Corrigendum - 4 dated 20/12/2025 to CPC Tender No. BHEL/CPC/KOD/EPC_AHP_PKG - II/26/058

Corrigendum - 4 dated 20/12/2025 to CPC Tender No. BHEL/CPC/KOD/EPC_AHP_PKG - II/26/058 for the work of “EPC Package (Package – II) for Main Ash Handling System of Unit#3 & Unit#4 at 2x800 MW DVC Koderma TPS Phase-II, Jharkhand”.

AMENDMENT NO. 6 TO BID SPECIFICATION

Technical Corrigendum-01

DWG NO.-3112-108-POM-A-910

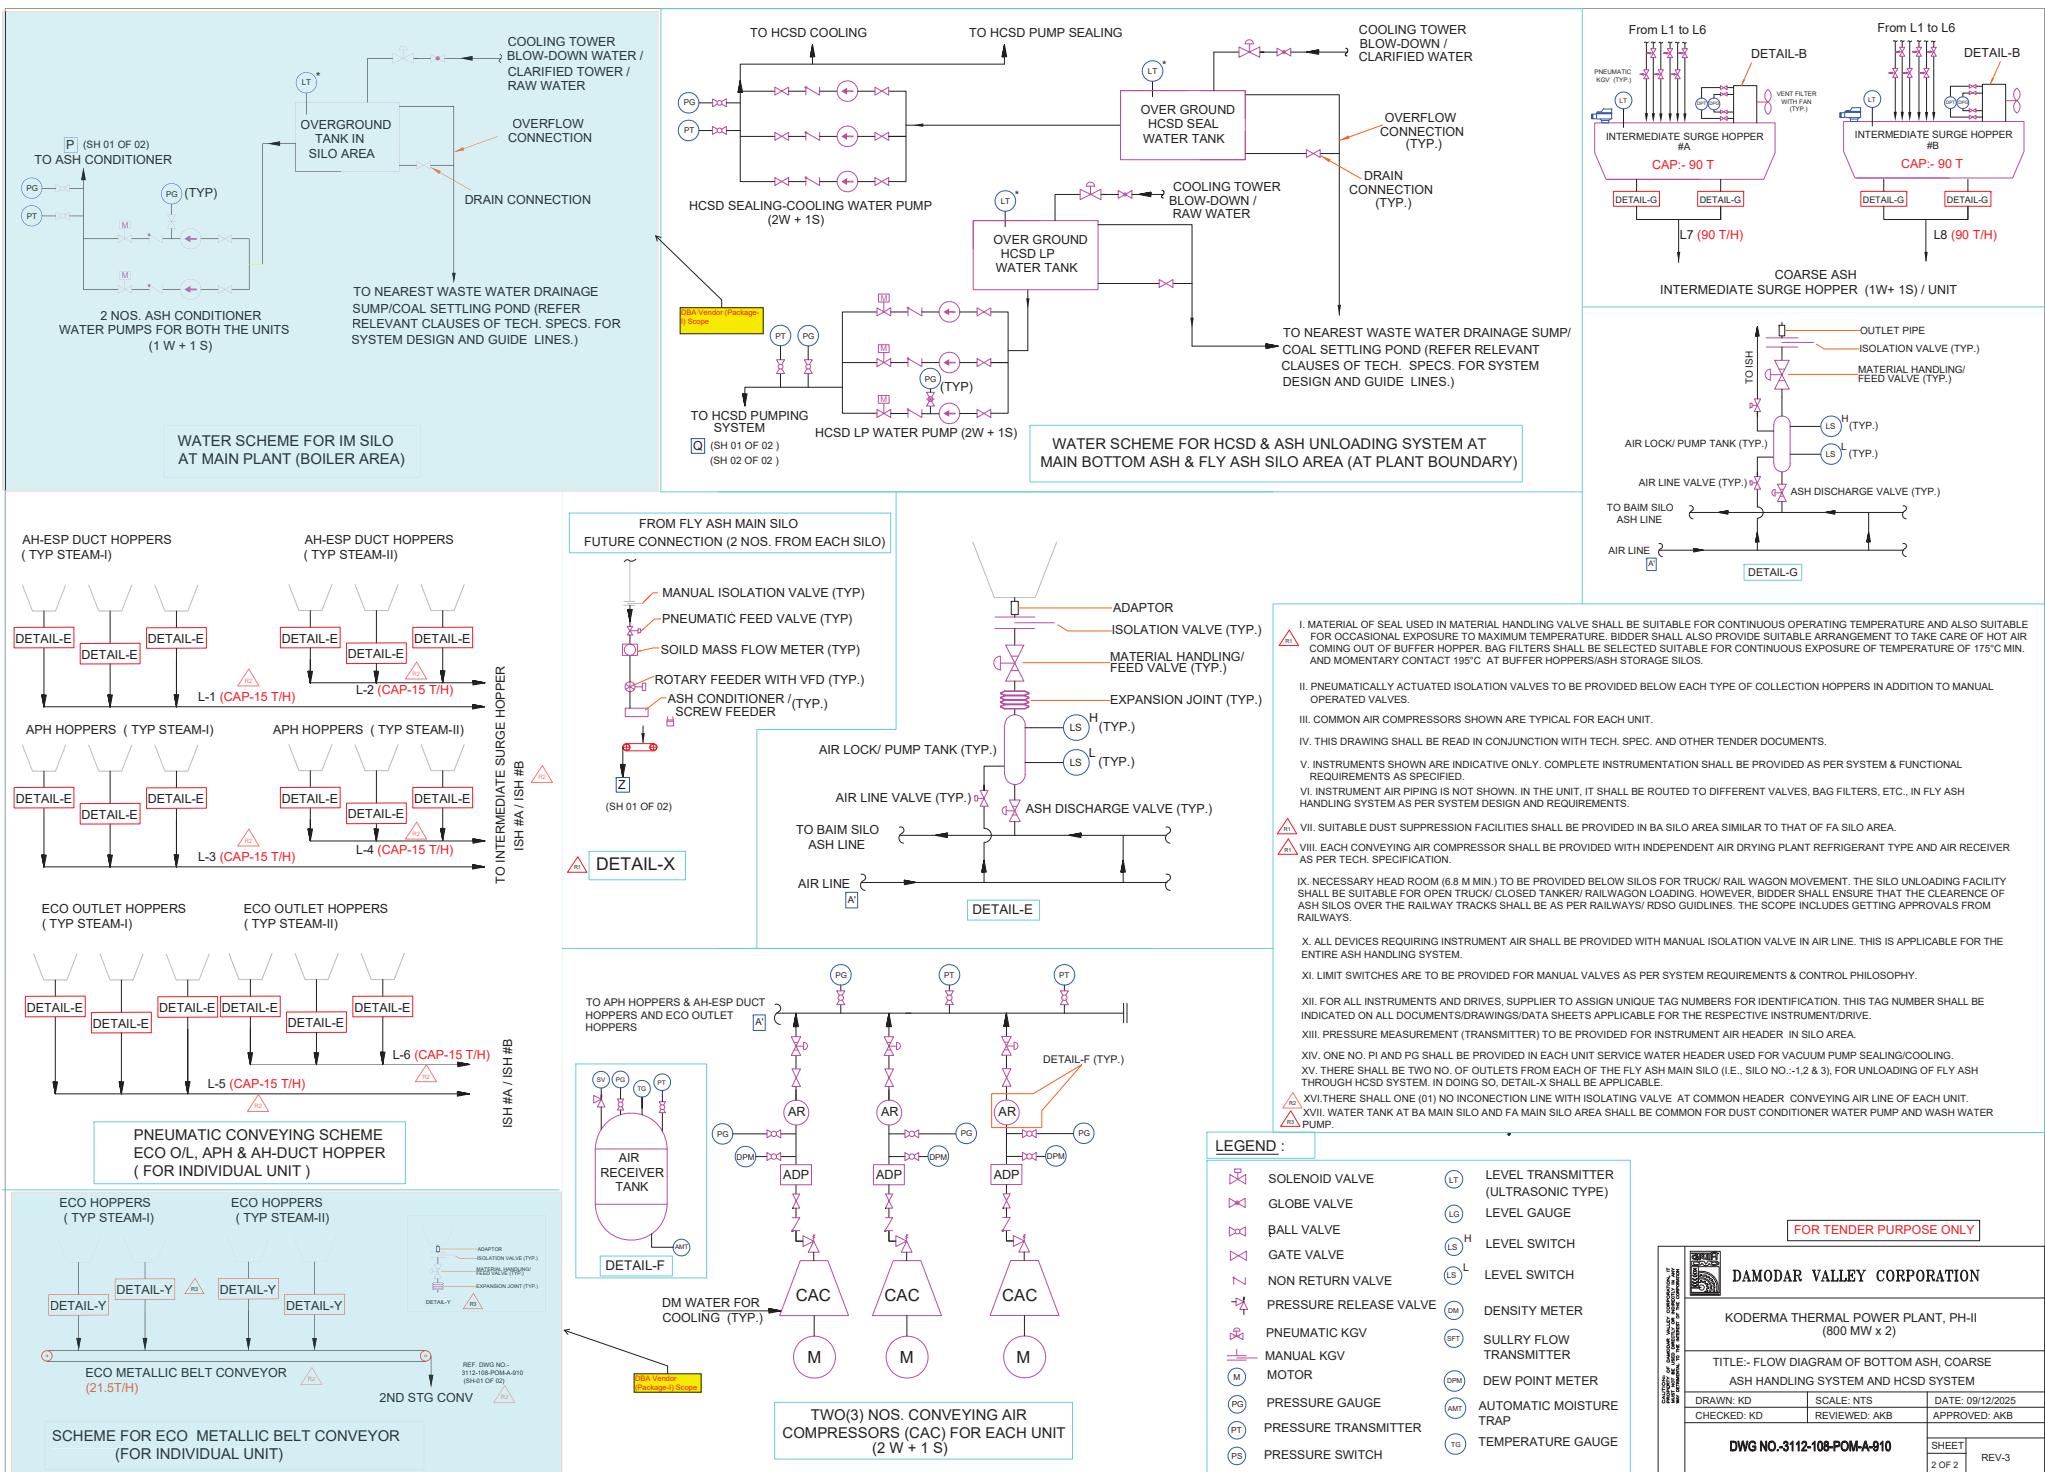
2.		General	<p>Please find Flow Diagram for Bottom Ash, Coarse Ash and HCSD System with Scope demarcation of Interface portion between Package-I and Package-II. However, bidder shall read the specification and scope matrix for detail scope.</p>
